Access Compliance Report Public Rights-of-Way (Curb Ramps)

Main Street: SHASTA_CT Cross Street: STARLIGHT_RIDGE Location: SW

ADA ID: RPRK211018174231 Ramp Type: Type 1 - Perpendicular Diagonal Initial Pass/Fail: Pass Overall Compliance: No Severity Score: 60

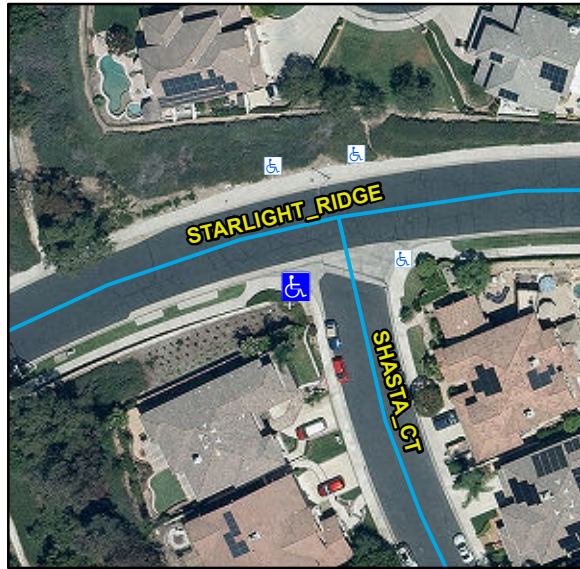
Compliance	Description	Data	Compliance	Description	Data
N/A	Ramp Length (in)	84	N/A	Flare Type LT	
Yes	Ramp Width (in)	48			Sloped
Yes	Ramp Run Slope (%)	2.1	No	Flare Slope LT (%)	18.3
No	Ramp Cross Slope (%)	11.8	N/A	Flare Traversable LT	Yes
N/A	Landing Present	No	N/A	Flare Type RT	
N/A	Landing Length (in)	N/A			Sloped
No	Landing Width (in)	N/A	Yes	Flare Slope RT (%)	5.4
No	Landing Run Slope (%)	N/A	N/A	Flare Traversable RT	Yes
No	Landing Cross Slope (%)	N/A	No	DWS Provided	No
N/A	Landing Movement Obstructed?	Yes	N/A	DWS Contrast	N/A
	Landing Movement Type	Curb	N/A	DWS Length (in)	N/A
N/A	Landing Shared	N/A	N/A	DWS Full Width	N/A
N/A	Clear Space	Yes	N/A	DWS Offset Left (in)	N/A
N/A	Clear Space To Crosswalk (in)	48	N/A	DWS Offset Right (in)	N/A
N/A	Marked Crosswalk 1	No	N/A	Marked Crosswalk 2	No
	Crossing 1 Direction	E		Crossing 2 Direction	N
	Marked Crosswalk 1 Width (in)	N/A		Marked Crosswalk 2 Width (in)	N/A

N/A	Ramp Inside Crosswalk 1	N/A	Yes	Ramp Inside Crosswalk 2	N/A
	Crossing 1 Slope (%)	6.7		Crossing 2 Slope (%)	4.7
	Crossing 1 Cross Slope (%)	4.7		Crossing 2 Cross Slope (%)	9.7
Yes	Gutter Ponding	No	No	Curb Slope	8
No	Gutter Lip Height (in)	0.25		Road Run Slope (%)	8.9
No	Gutter Run Slope (%)	5.1		Road Cross Slope (%)	3.5
No	Gutter Cross Slope (%)	9.7			
Yes	Overall Surface Condition: Acceptable		Yes	Perp Joint Present	Yes
	Cross Gutter Present?	Yes		Spandrel Present?	Yes
	Replace Cross Gutter?	No		Replace Spandrel?	No

Remove & Replace Curb Ramp With Two New Directional Ramps or Equivalent. Remove & Replace Gutter.
